# 802.3bz Layers – CL45 Management Proposal

# CL45 MANAGEMENT PROPOSED CHANGES

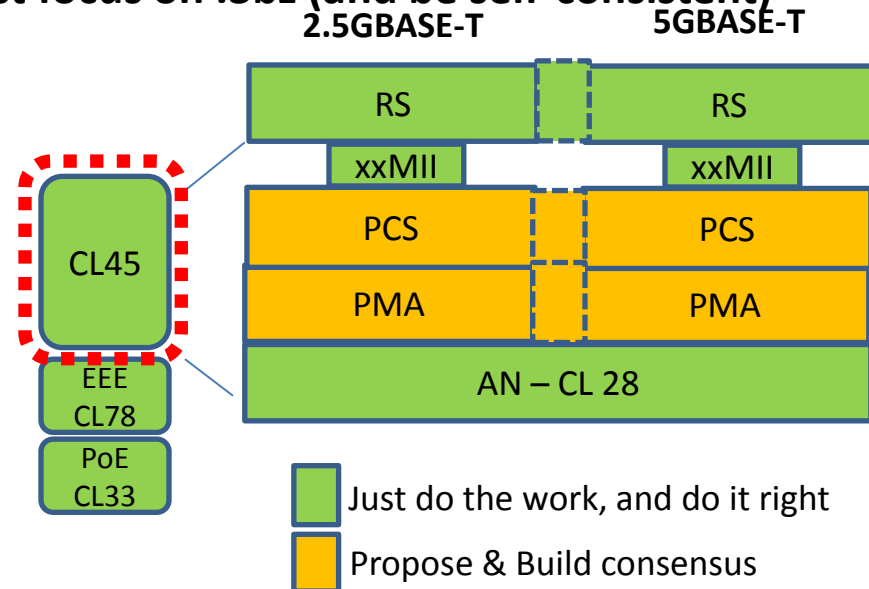
Note: .3by does not have CL ref in its table.
